# UNITED STATES PATENT AND TRADEMARK OFFICE

APPLICATION NO.	FILING DATE	FIRST NAMED INVENTOR	ATTORNEY DOCKET NO.	CONFIRMATION NO.
10/528,917	03/23/2005	Peter R Ebner	MAX 02.01CIP	9044

## Office Action Summary

## **DETAILED ACTION**

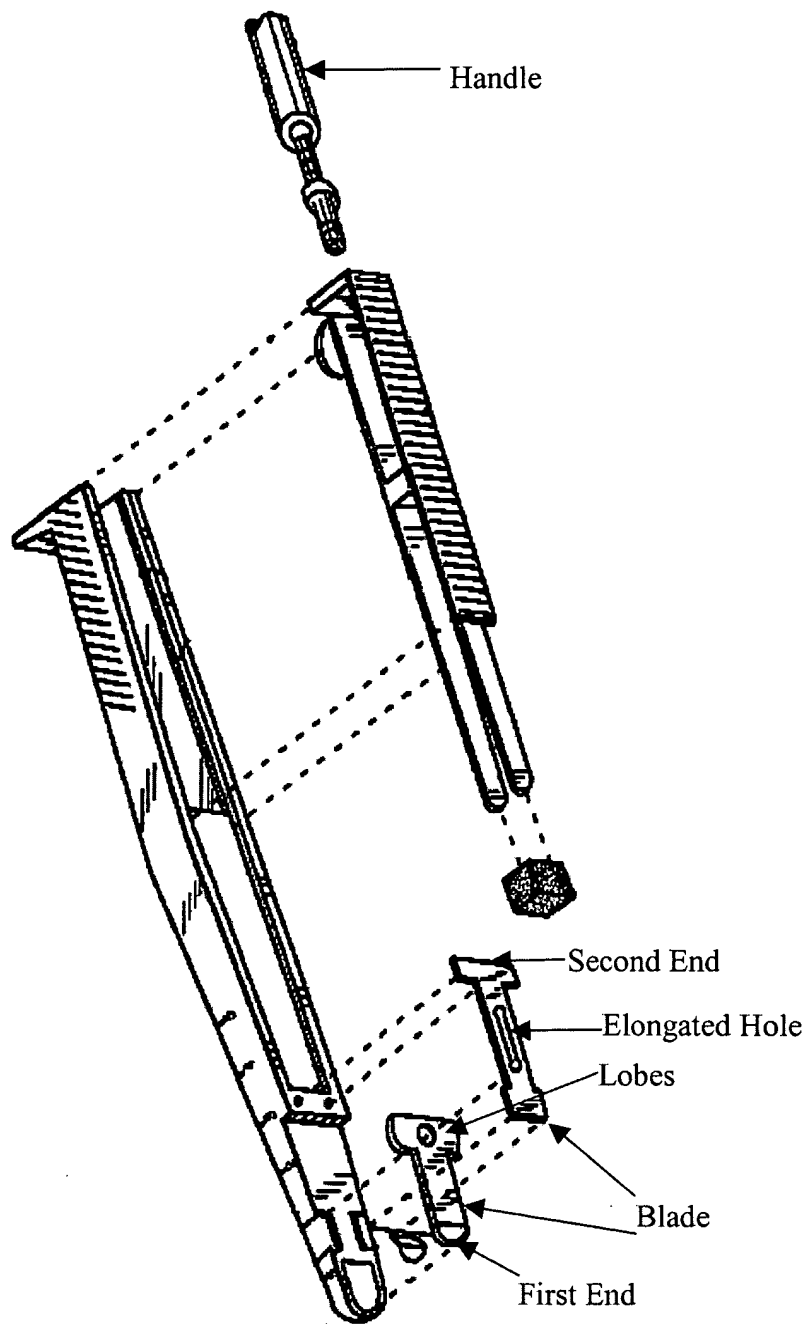
Regarding claims 1 and 86, Altobelli discloses an instrument comprising a generally planar blade, a collection chamber with an upstanding retention member, and an elongated handle coupled to the end of the collection chamber (see Figure 1 below). The blade comprises a first end, a second end, and a middle section. The first end comprises a cutting edge and an opening. The middle section comprises at least one outwardly extending lobe. Altobelli also discloses that the collection chamber of the instrument can be used as a mixing chamber (column 4 lines 61-67; claim 86).

Regarding claims 70 and 89, Altobelli discloses a blade comprising a first end, a second end, and a middle section. The first end of the blade comprises a cutting edge and an opening. The middle section of the blade comprises a pair of extending lobes on either side of a centrally located elongated opening. Regarding 89, Altobelli discloses a blade wherein the second end comprises two protrusions to facilitate the extraction of the blade from the collection chamber.
